J(BdL) curves for CEBAF dipoles from 3D magnetostic models

Jay Benesch

This TN was sent to the 12 GeV Project team for review July 17, 2008. Comments received from the team on Nov. 13, 2008, are given in the appendix.

Appendix - comments from the 12 GeV Project team

AM dipole - rollover magnet in arc 3

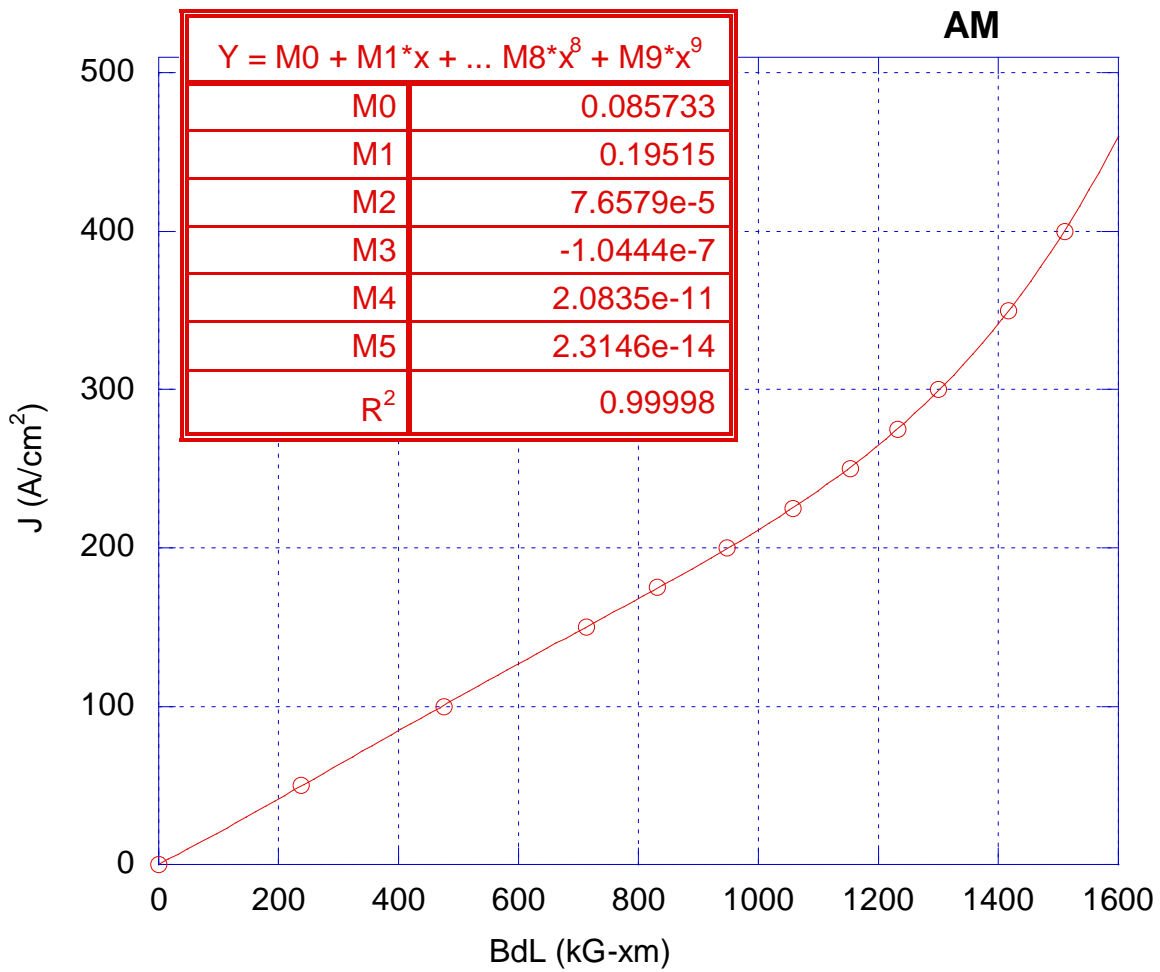
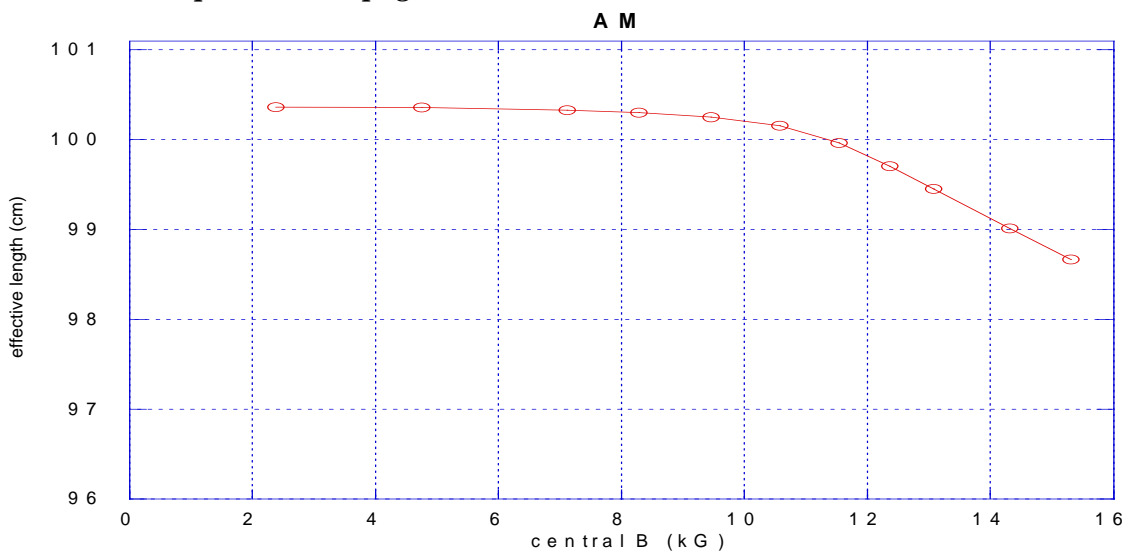
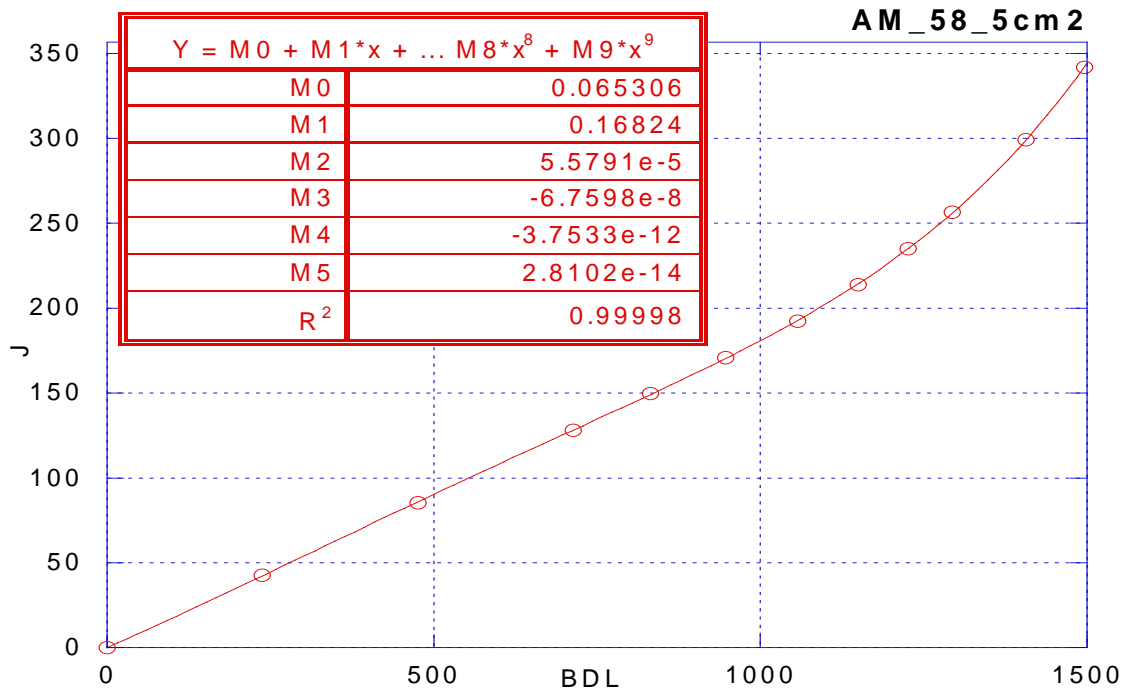
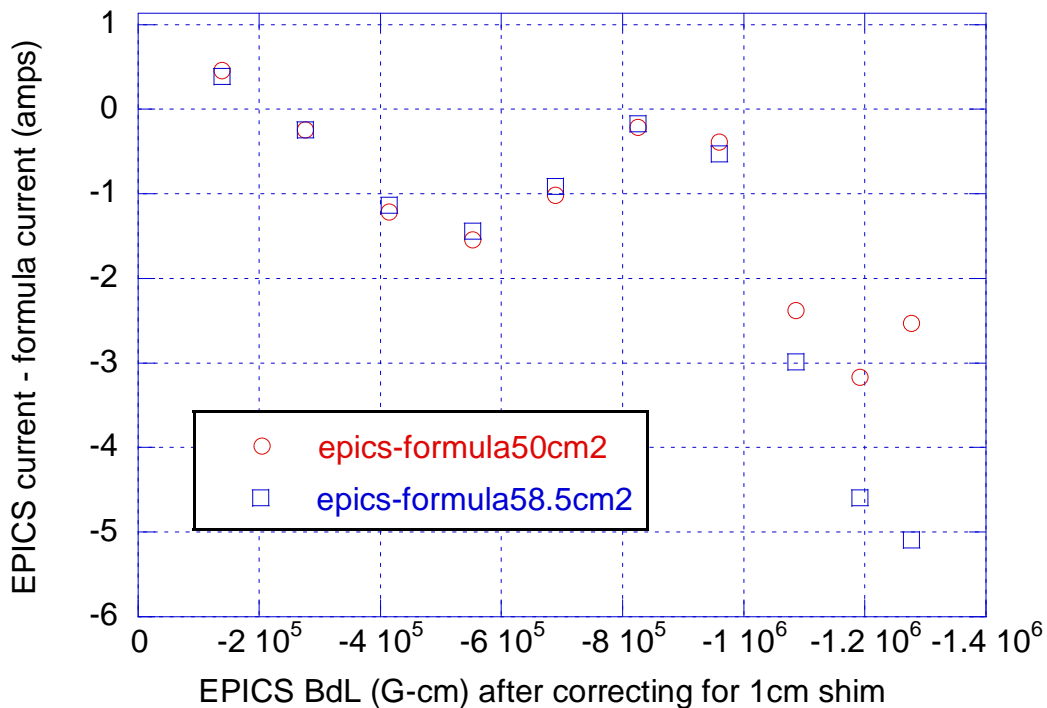
- Pg 18, 2nd paragraph: The 3rd sentence asserts that the B-H curve is wrong above 10.5kG. It could well be wrong, but 10.5 kG (which is the gap field if I'm reading the stuff right) is not the value of interest. The saturation depends not on the gap field but on the field in the iron. The AM and AN saturate "early" specifically because the field in the pole root is significantly higher than the gap field. The objection on this paragraph is removed if the words "above 10.5kG" are removed.

- Pgs 18-20: The two different coil sizes are confusing. Why is anything other than the real coil cross-section (which the document doesn't identify) being used? The document needs to explain why the comparison is being done before it starts listing results from said comparison.

AN dipole - rollover magnet in arc 5**Coil cross section 5x10 cm². Steel 96.088 cm long. "Shunt adders" needed for 6 GeV**

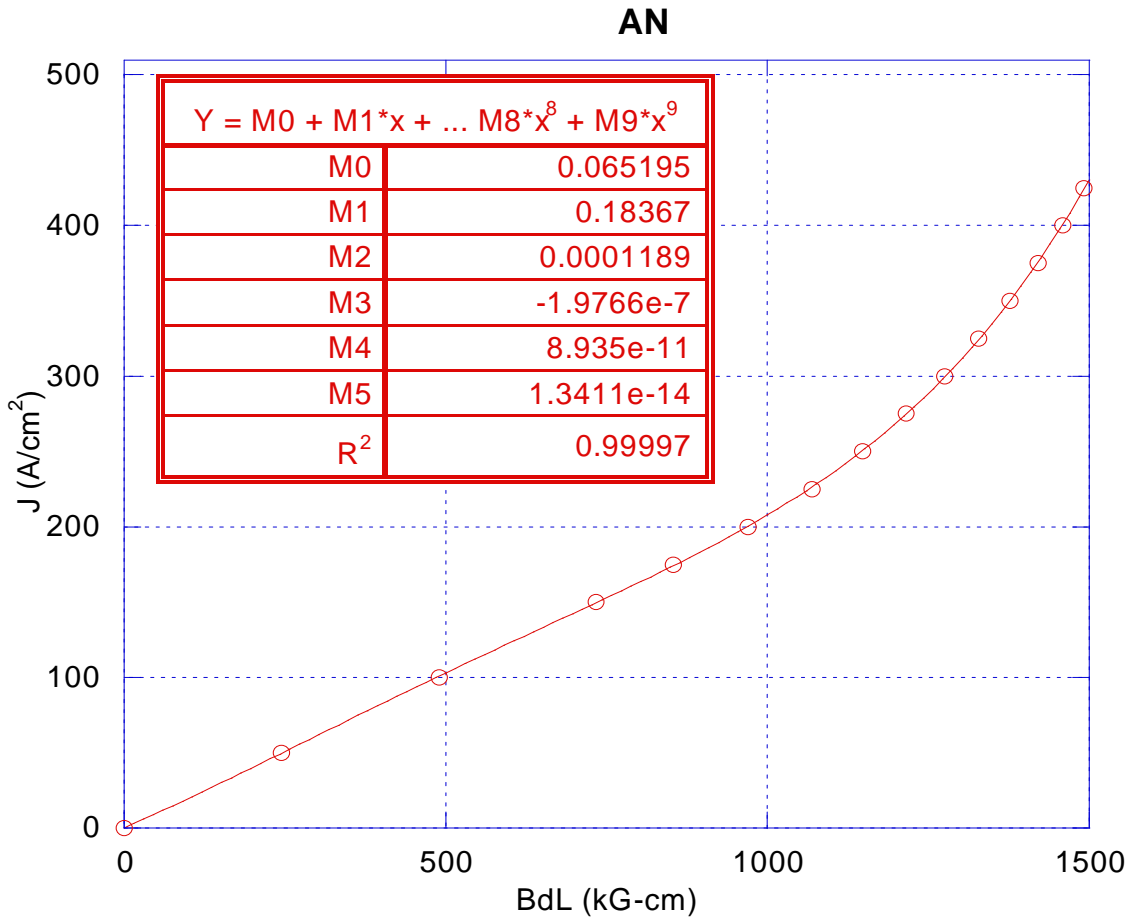
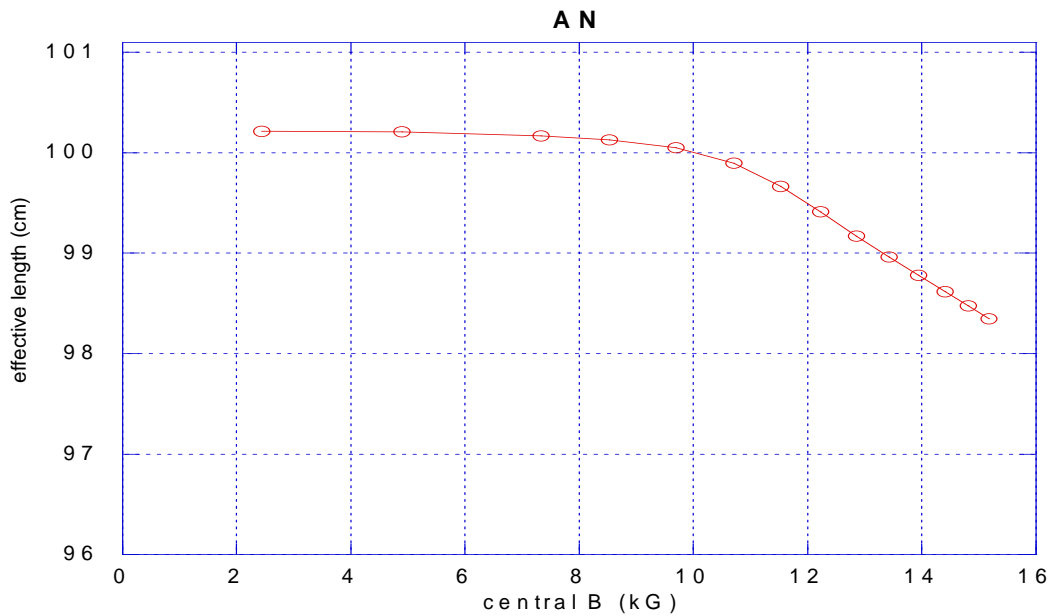
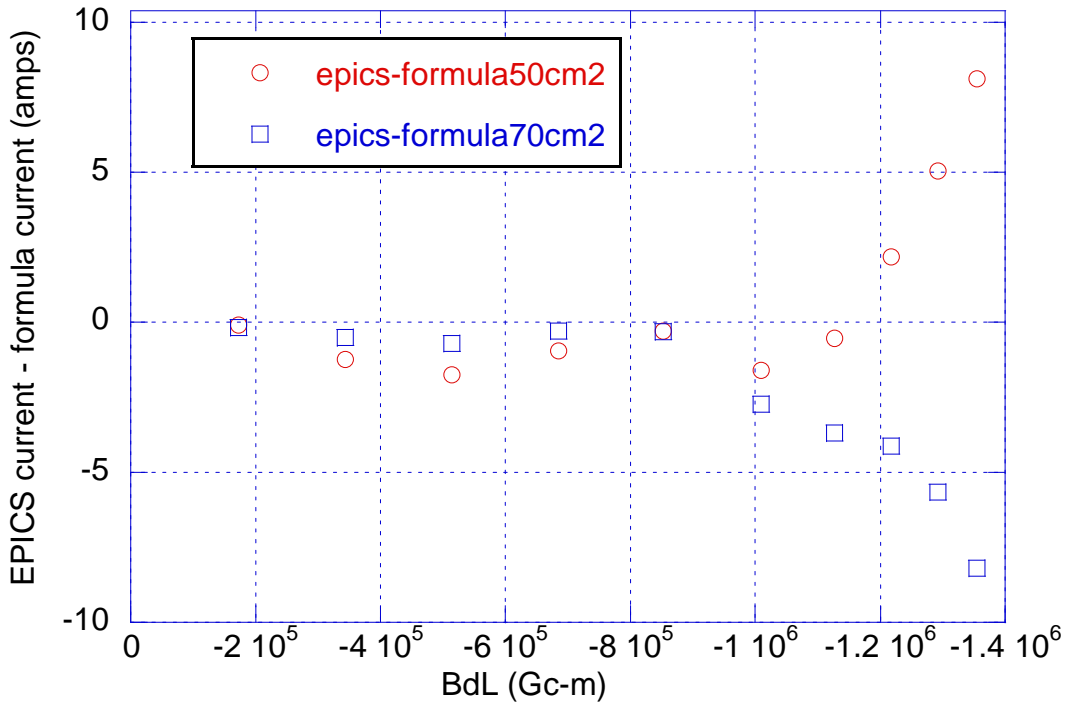
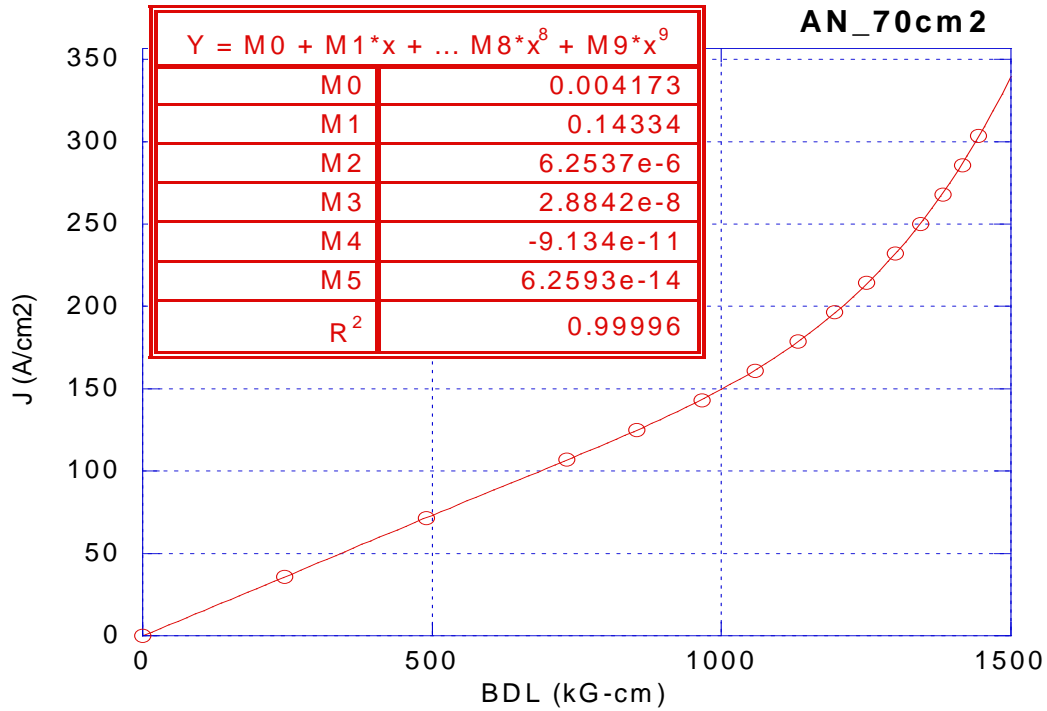
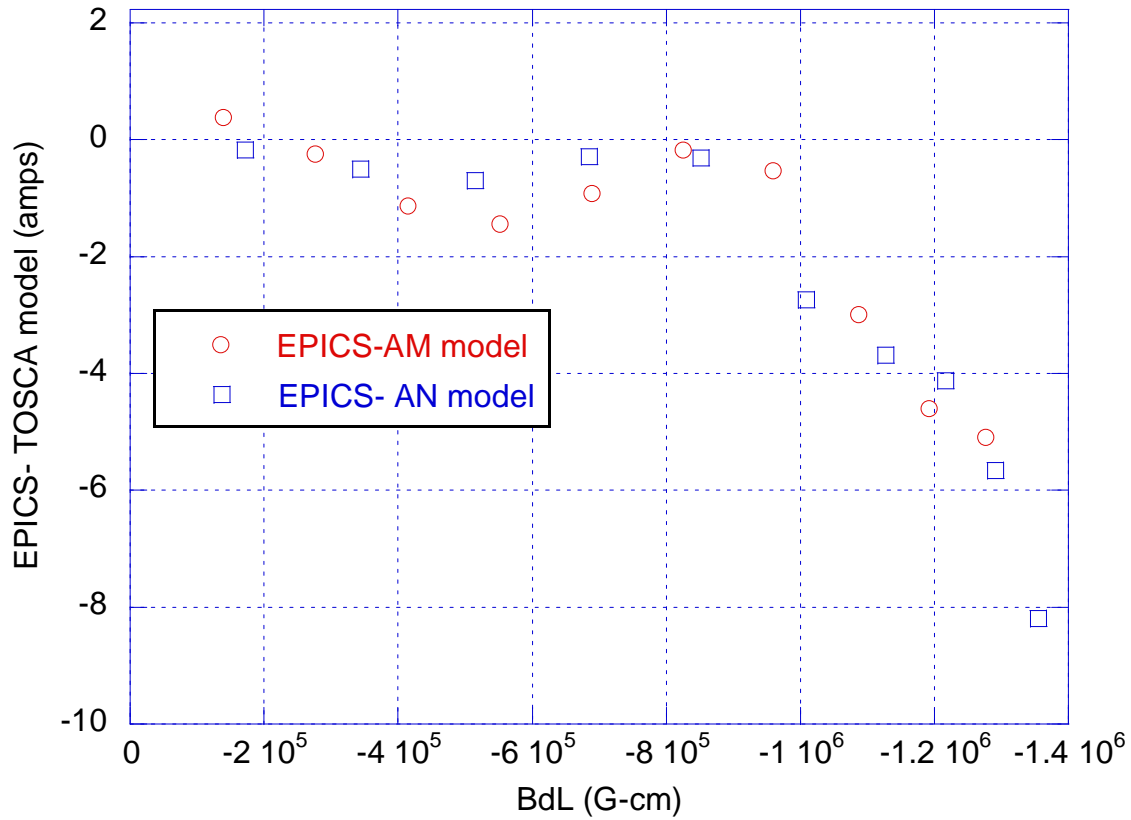
- Pgs 21-23: Same comments as for 18-20
- Pg 20 & 23: Unclear what is meant by "flux from the longer coil is outside the pole gap proper" or "shot coil couples better to the gap". Without knowing how the actual iron and copper configurations differ between the short and long coil cases, the validity of the statements can't be ascertained. Specifically, the statement is incorrect for some iron/copper configurations and thus over-general; this could result in some readers reaching the wrong conclusion.
